RECALL CAMPAIGN 16V-333: ISOFIX CHILD RESTRAINT SYSTEM ANCHORS

This Service Information bulletin supersedes SI B41 01 16 **dated November 2016**.

F25 (X3)	F26 (X4)
----------	----------

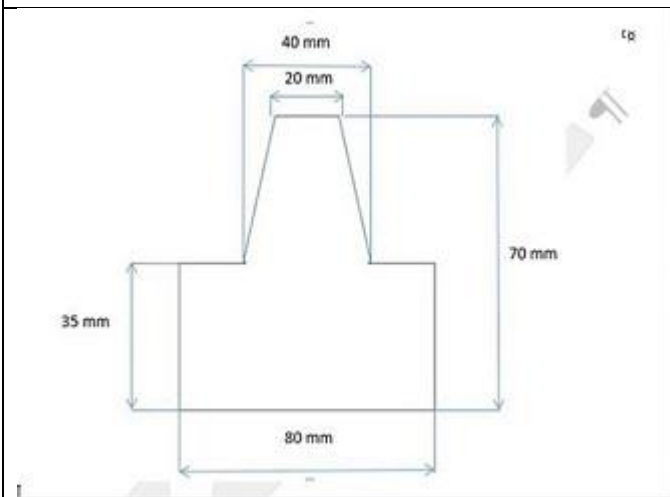
14. Install reinforcement bracket as shown. Secure bracket with suitable clamp.
Note: It may be necessary to remove galvanized coating on reinforcement bracket to ensure a quality weld.

15. First, weld the left side of the bracket, progress to the top of the bracket as shown. Then continue to weld the left side of the remaining brackets as to allow time to cool.

16. Then, weld the right side of the bracket. Continue to weld the right side of the remaining brackets to allow time to cool.

<p>17. Weld a continuous bead of weld to connect the left and the right sides. Complete all remaining brackets in this manner.</p>
	<p>18. Example of properly executed weld is shown. Notice, the welding bead is continuous from left to right side.</p>
	<p>19. Once the welds have sufficiently cooled, prepare the areas to re-apply anti-corrosion protection. Use a stainless steel brush to clean the weld before applying anti-corrosion protection.</p> <p>Note: Anti-corrosion protection can be sprayed on or applied with a brush. Product used does not have to be body color.</p>

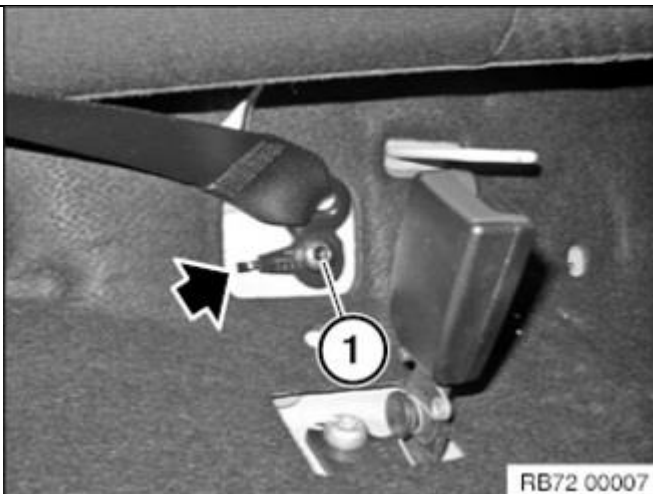
21. Cut supplied felt pads to the dimensions shown.
Note: Picture at left, not to scale.

22. After anti-corrosion protection has dried sufficiently, install felt pads.

23. Lower view of felt installation.
